## MSPM0L1105 Dev Board

Sheet: /  
File: MSPM0L1105\_dev\_board.kicad\_sch

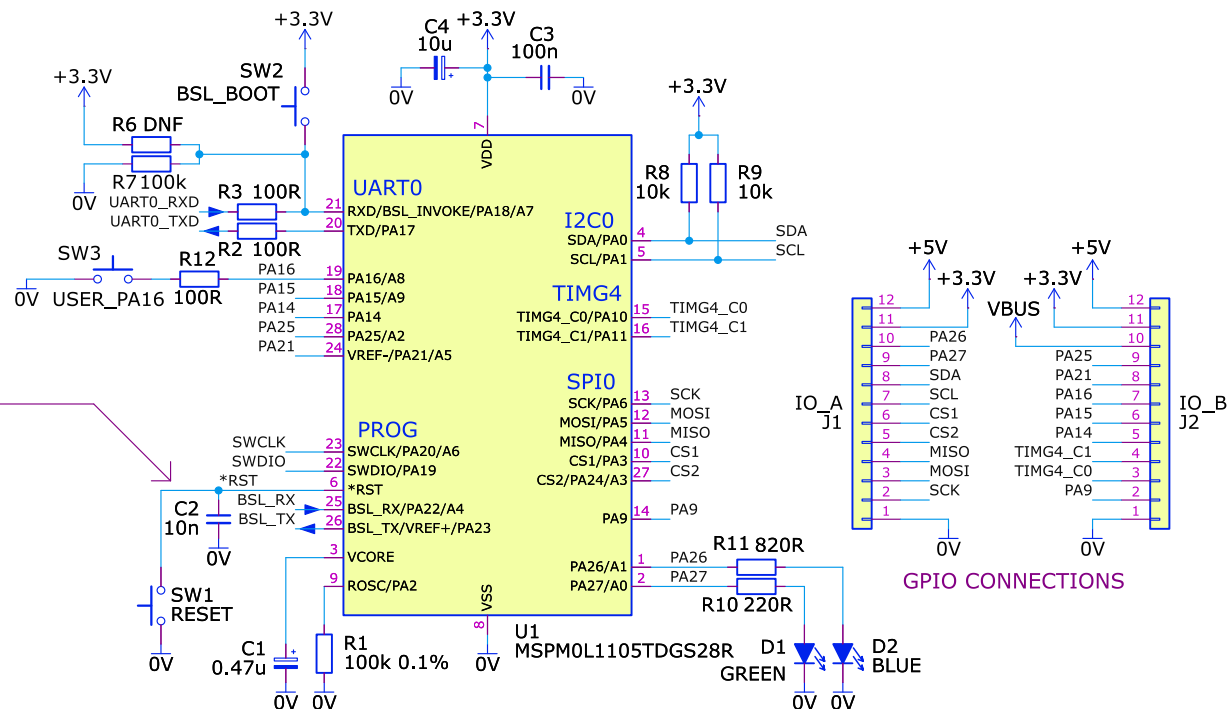
Rev 1 PCB is missing a 47k pull-up resistor from the \*RST pin (pin 6) to +3.3V.  
To make the board work, patch a 47k resistor onto the board underside.
